FINAL ENVIRONMENTAL ASSESSMENT

SQUAK VALLEY PARCEL, ISSAQUAH,
WASHINGTON

July 2004

The Corps received comments on the draft environmental assessment (EA) for the proposed environmental restoration project at the Squak Valley parcel from 4 stakeholders. Specific comments and questions (*in italics*) are presented below, followed by Corps responses.

Figure A-3. Site Plan – North.

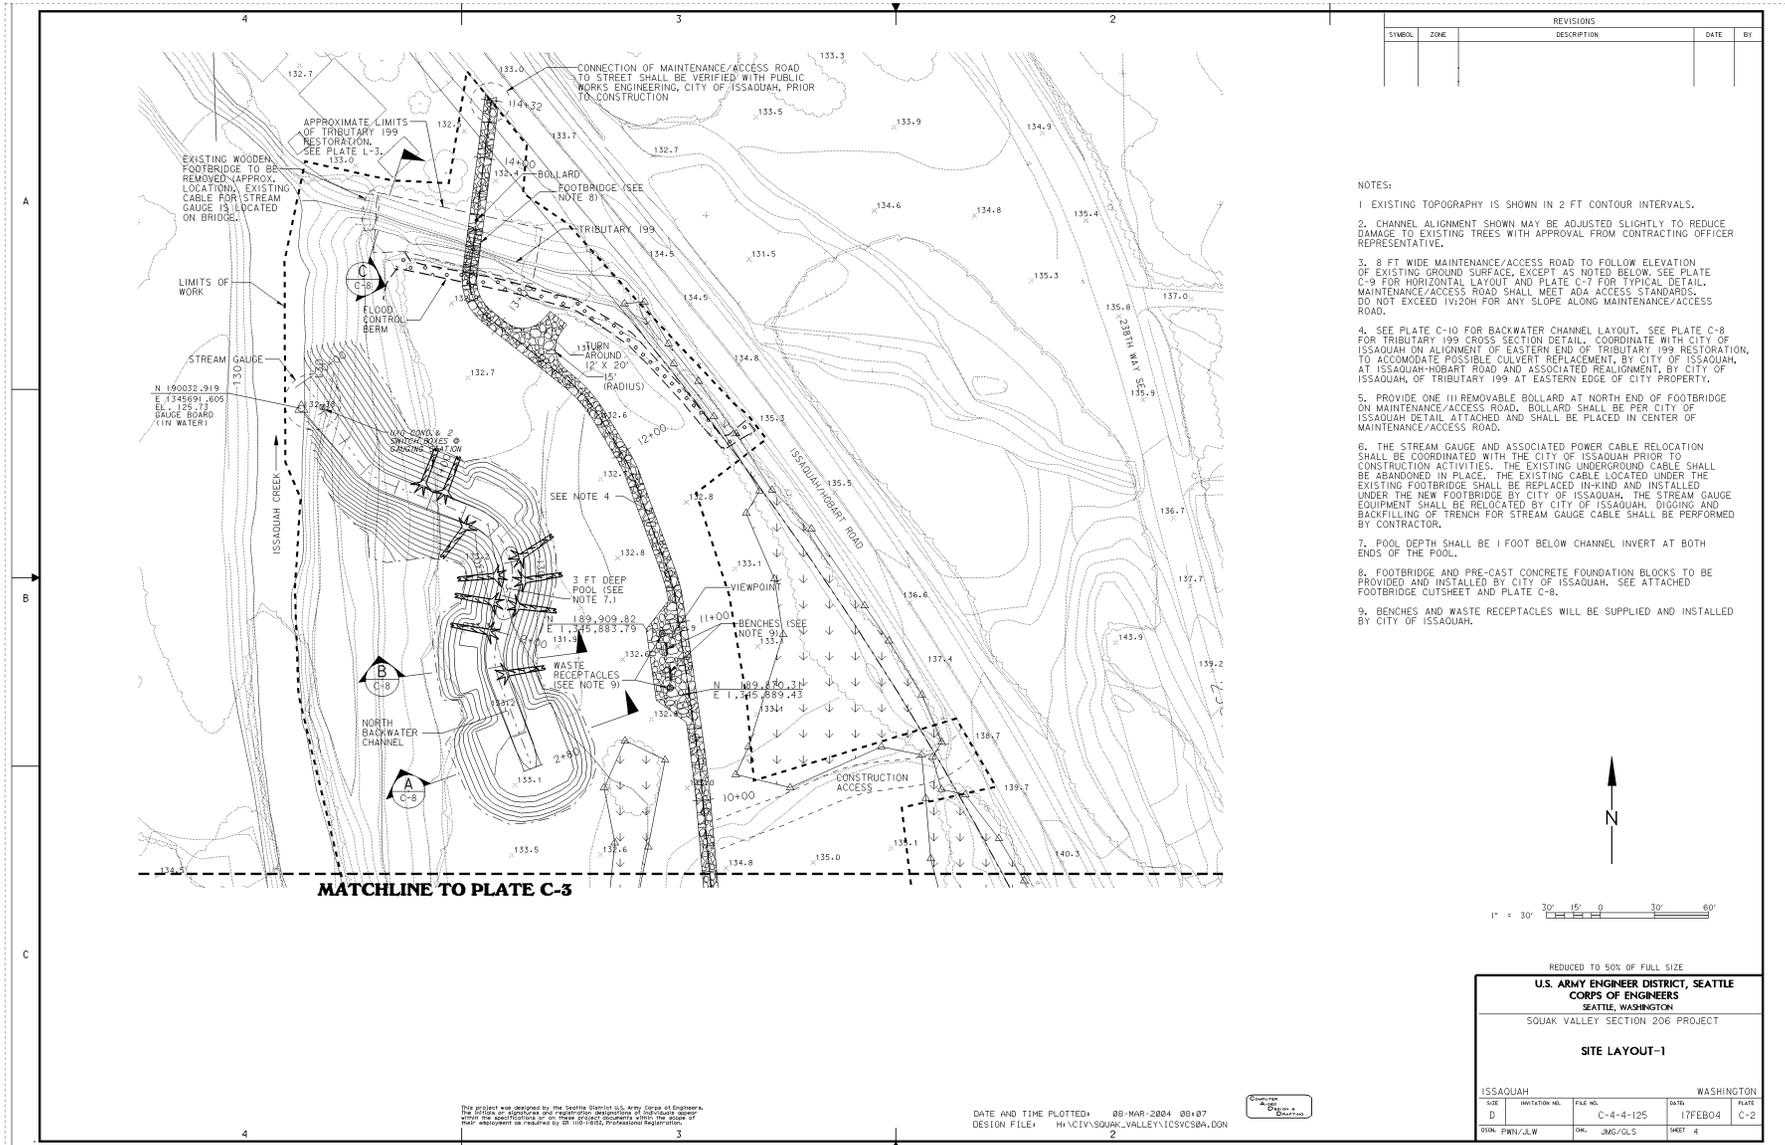
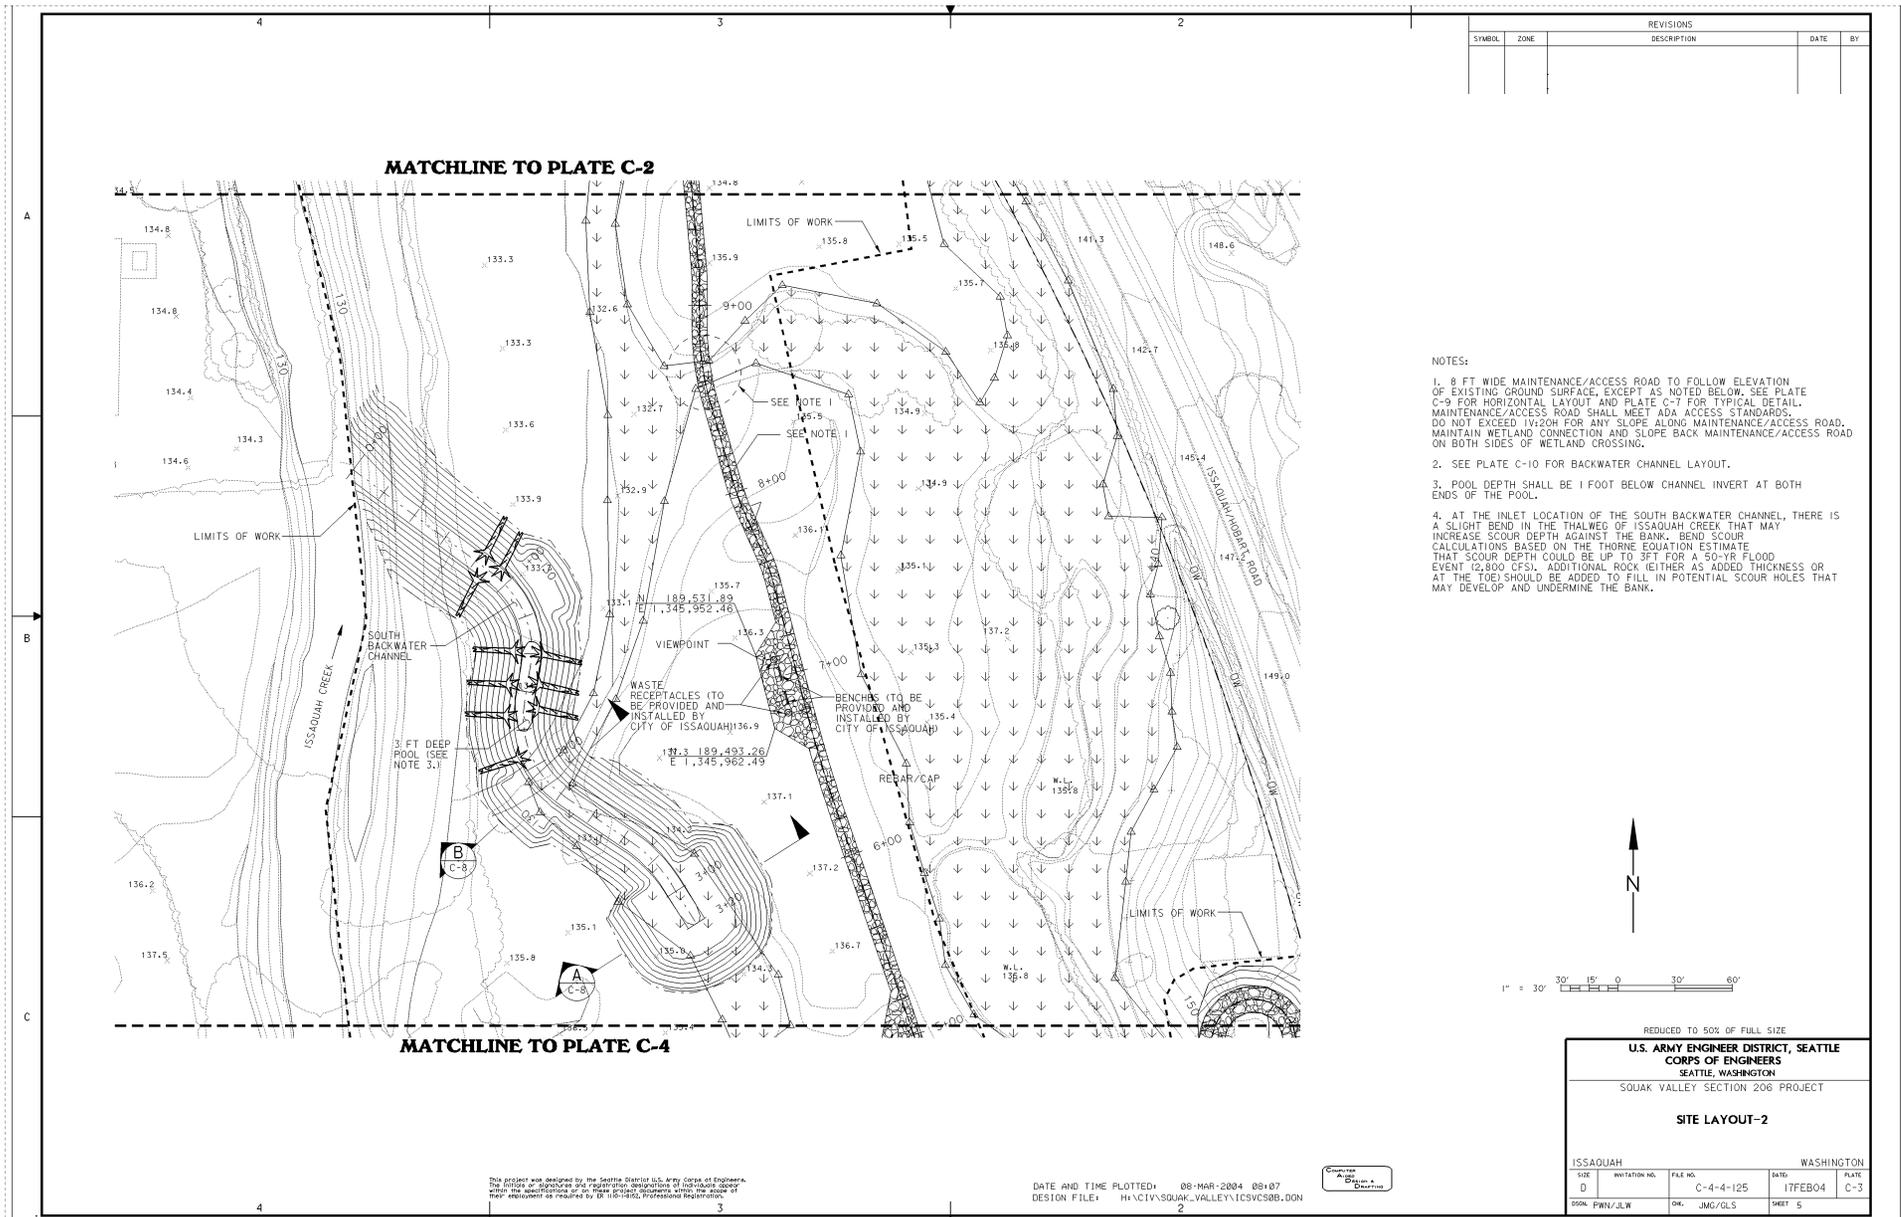
ix. Wood should be placed near the mouth to provide immediate cover for juvenile salmonids that enter the backwater channels. Placed wood should also be clumped rather than placed in isolation as shown in Figures A-3 and 4. Each piece of wood should have a rootwad and be clumped using large and small pieces to provide more habitat complexity. Additionally, Figure A-10 indicates that the full length of the wood stem is to be placed into the stream bank, with little wood actually in the channel. Since the intention is to create two backwater channels, the majority of the wood does not need to be placed in the bank for stability because there should be little potential for erosion or channel avulsion. Similarly, the backwater channels should not require riprap if they are designed correctly (Figure A-11). Wood should also be placed into Tributary 0199 (Kees Creek) to provide cover and habitat for salmonids in addition to the riparian plantings and streambank setbacks.

As discussed in comment and response 4(i), the design specifically avoids modification of the main channel of Issaquah Creek to minimize the chance for adverse off-site impacts. Accordingly, LWD will be located in the backwater channels rather than at the outlets. As shown on drawings A-3 and A-4, the woody debris will be clumped around the pools in order to maximize the habitat complexity in the area of the channel most likely to be utilized by juvenile salmonids, particularly coho salmon. Per evaluation of buoyancy and depth of floodwaters, the woody debris is buried into the bank to prevent it from floating away during flood events, with likely adverse effects downstream. As with Issaquah Creek, work in the channel of Tributary 0199 will not include placement of woody debris to avoid altering the hydraulics of the channel and minimize the chance that the habitat enhancements increase the likelihood of flooding Issaquah-Hobart Road.
